**BRIDGE - UNSPECIFIED  
BRF-001-5(106)--38-52**

**RALSTON CREEK 2.3 MILES S. OF I-80 (NB)**

*KIDP  
PL 10  
PROJECT  
8-19-16  
:)*

**D3 PLAN - Date: 8-19-2016**  
**D5 PLAN - Date: 12-16-2016**  
**D4 PLAN - Date: 6-19-2018**  
**B3 PLAN - Date: 8-7-2018**

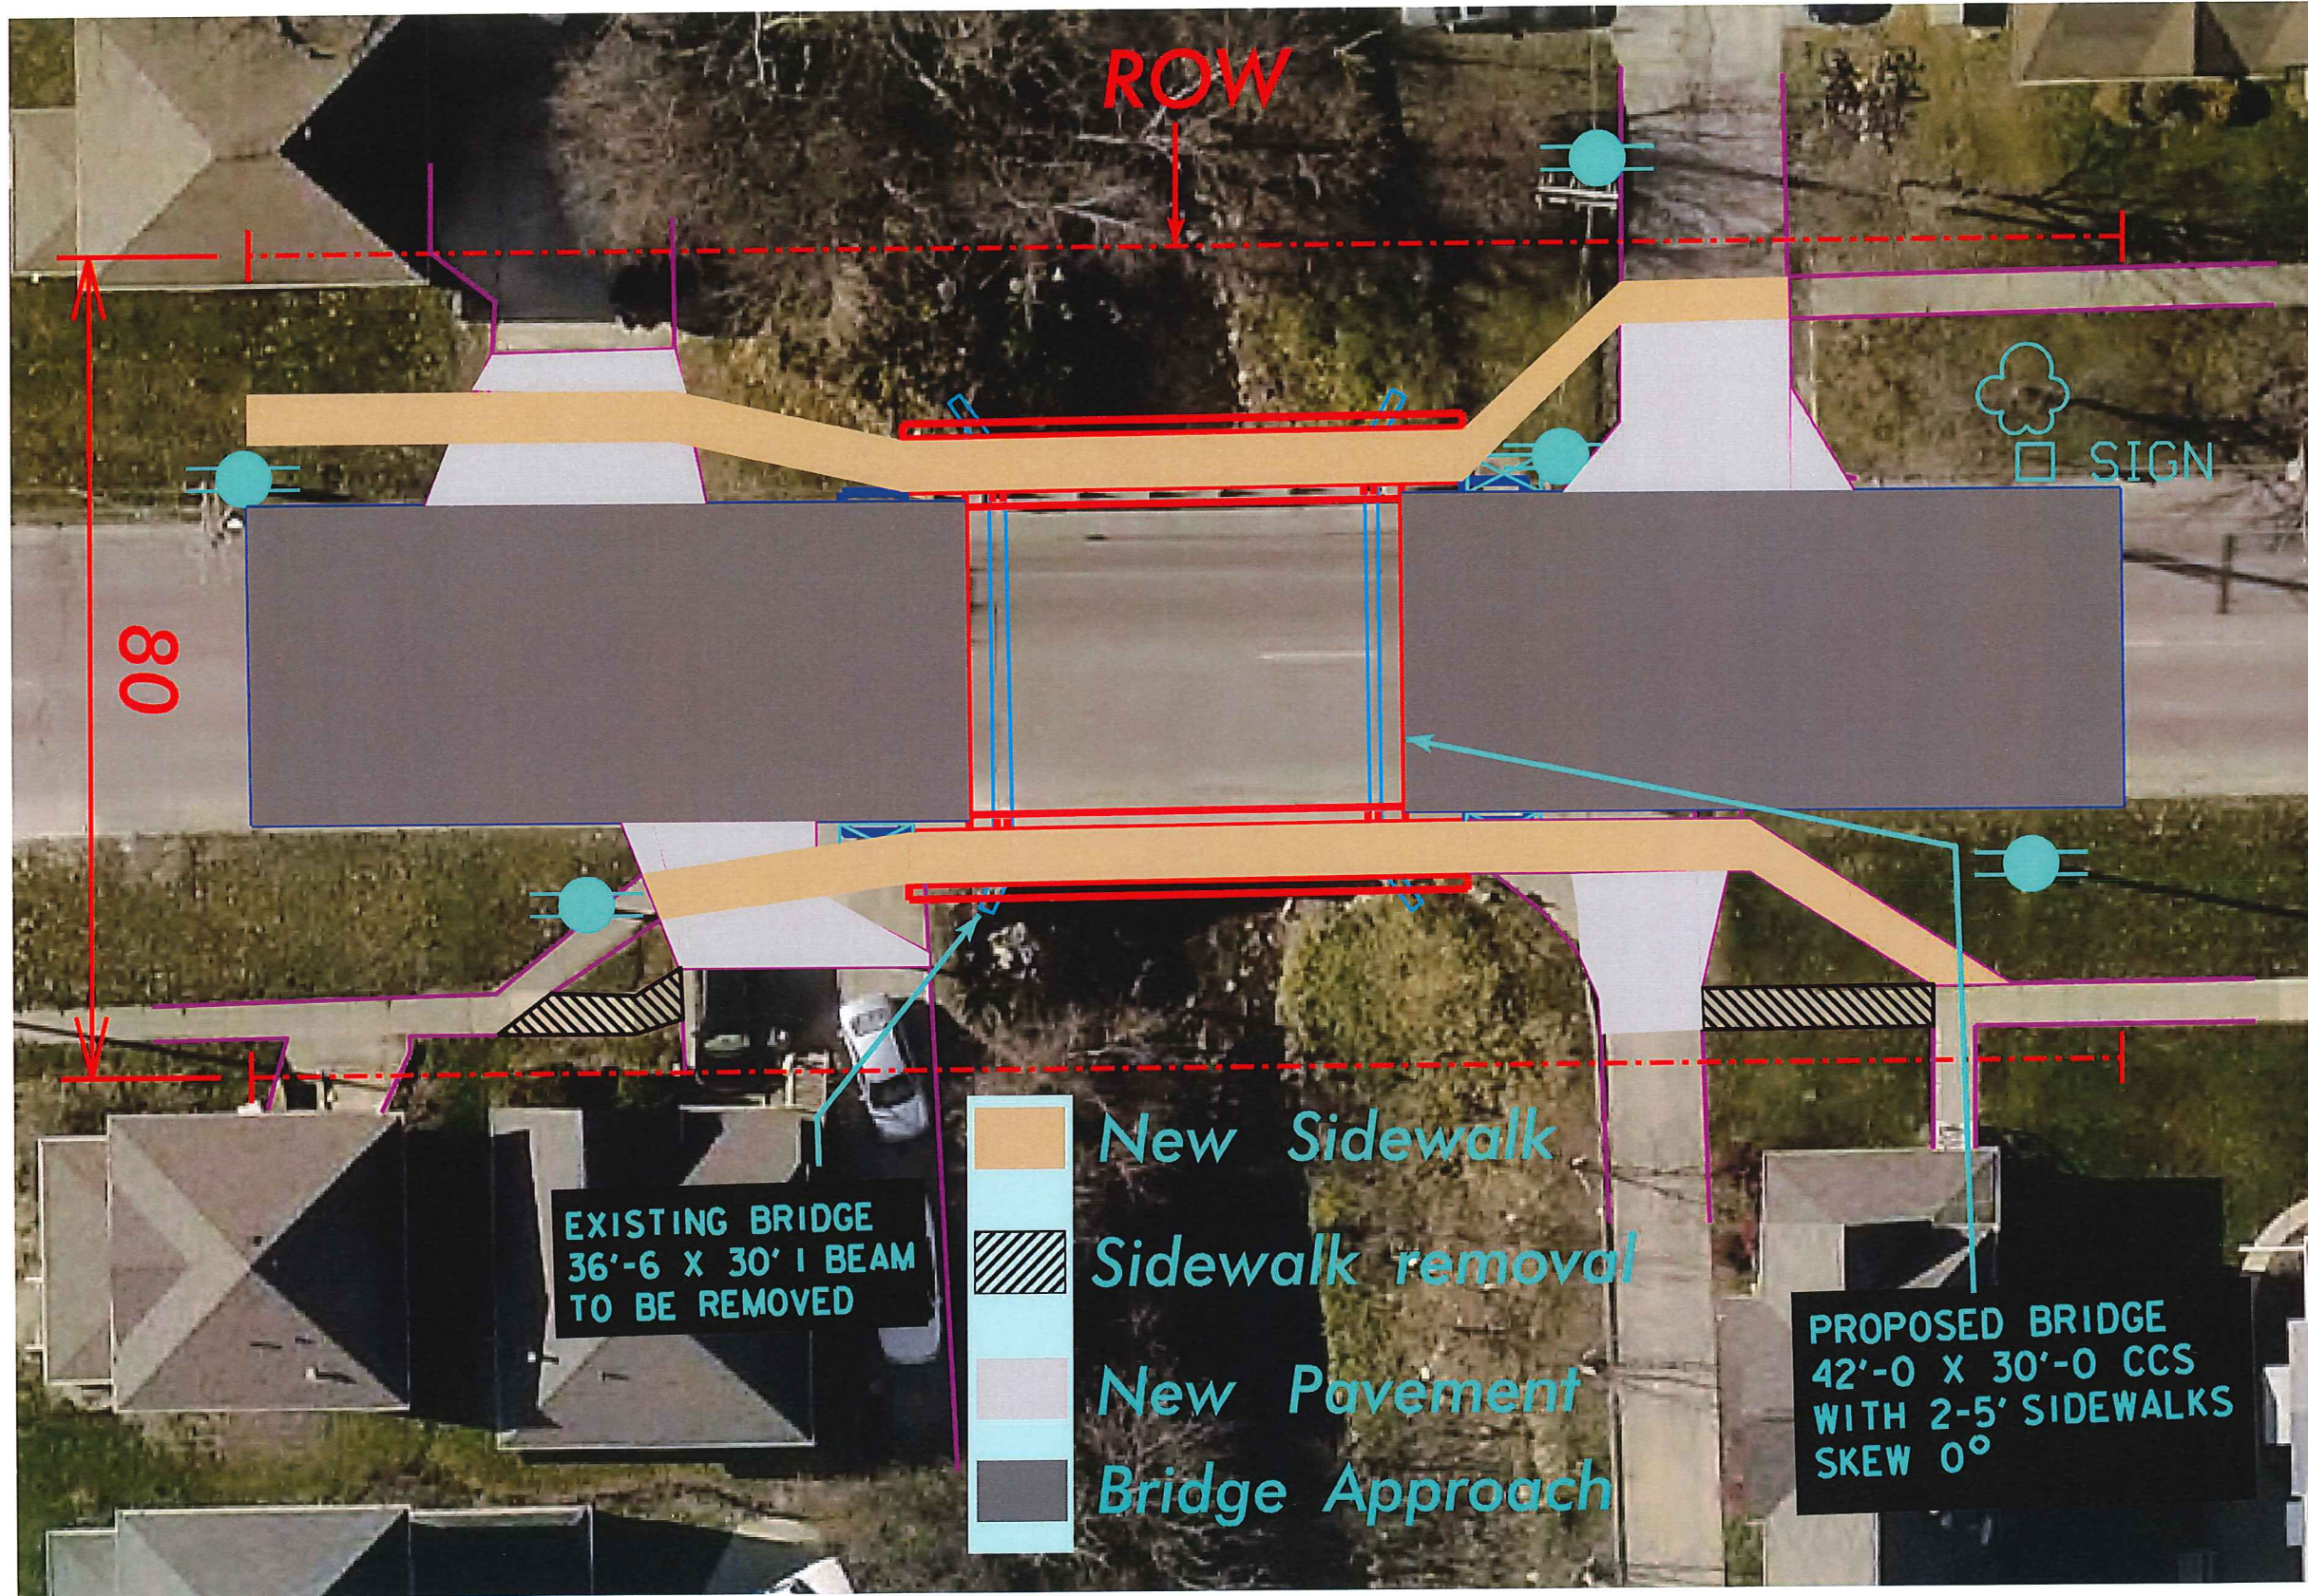
*Use Burlington Street rail*

Sta. 3+00  
Build 42' x 30'  
Continuous Concrete Slab Bridge  
With two 5' Sidewalks  
Skew 0°

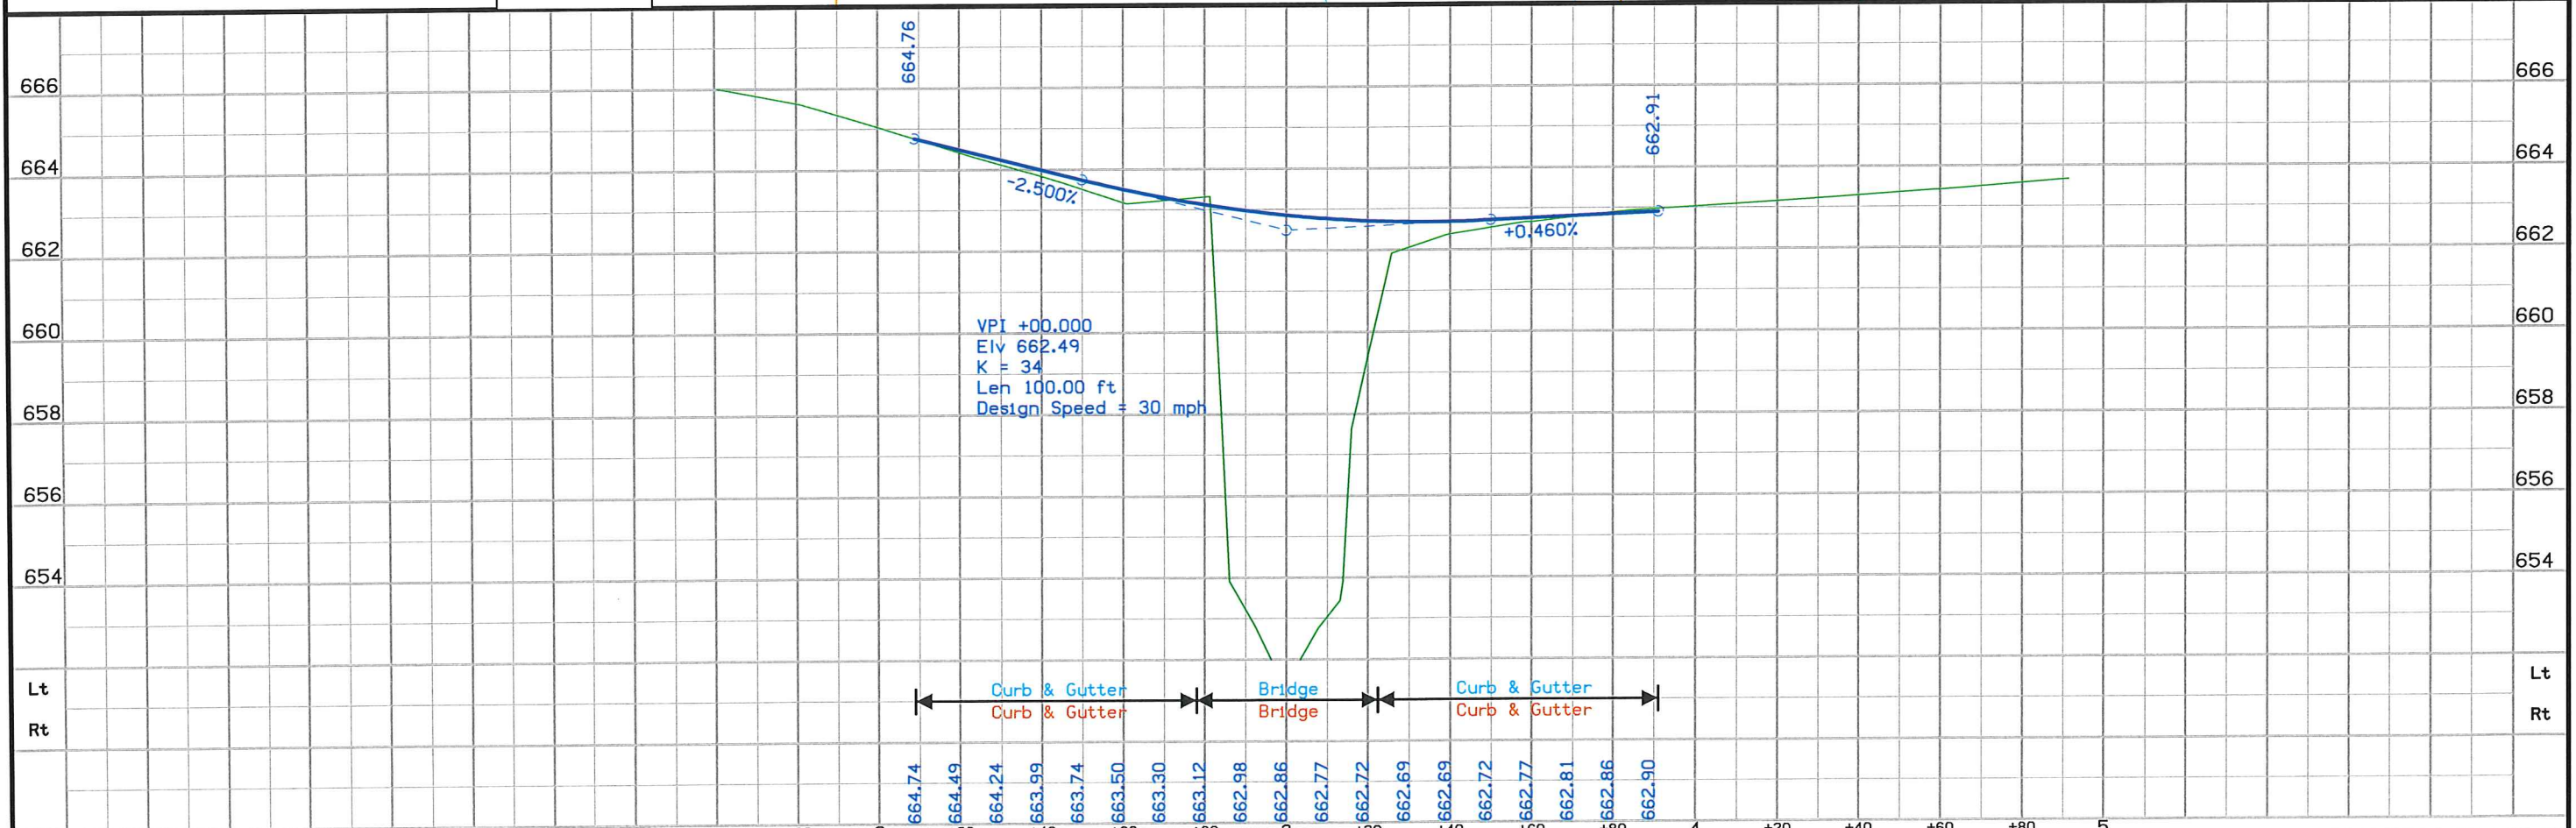
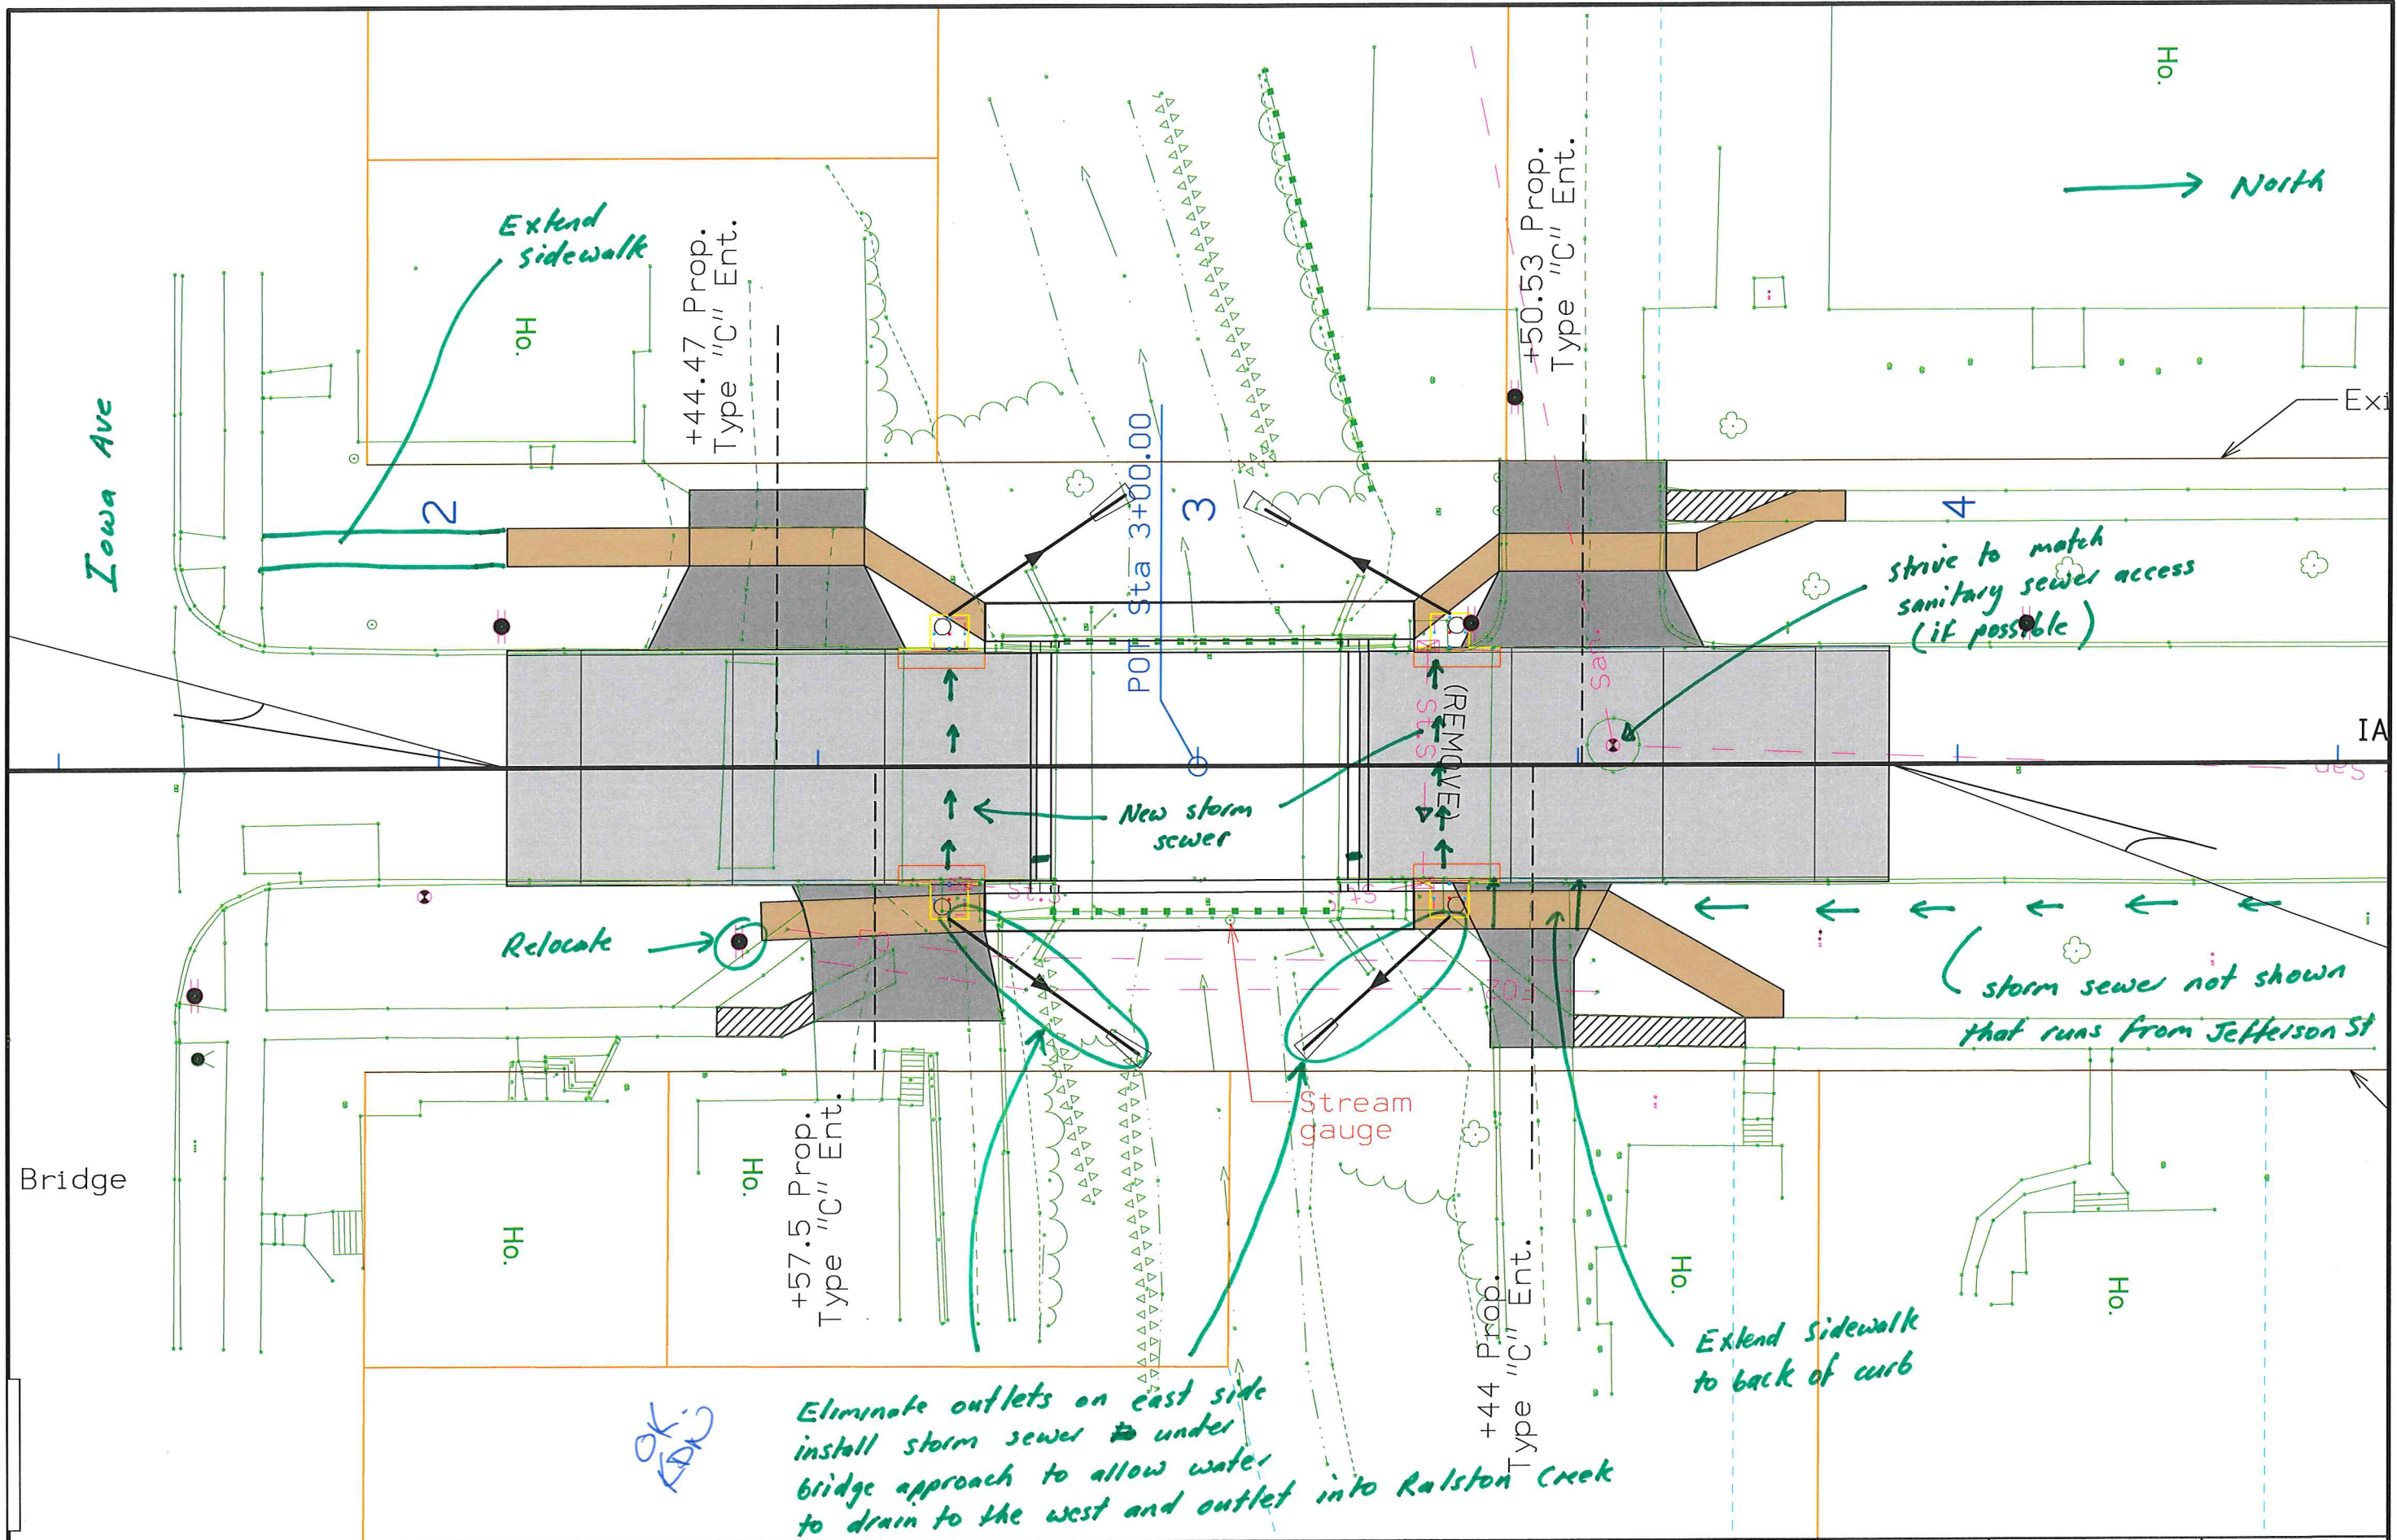
*(See next page  
for F.E. Comments)*

**TRAFFIC CONTROL PLAN**

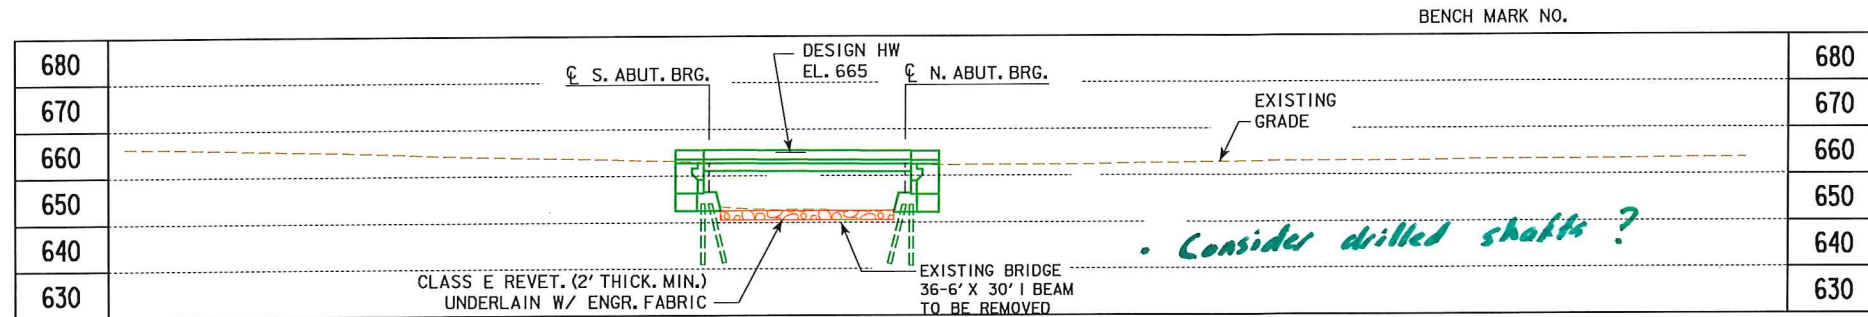
*No! Vehicular access to properties will not be maintained. Pedestrian access will however be maintained at all times*

*2 Detour signs will be installed by the contractor.*
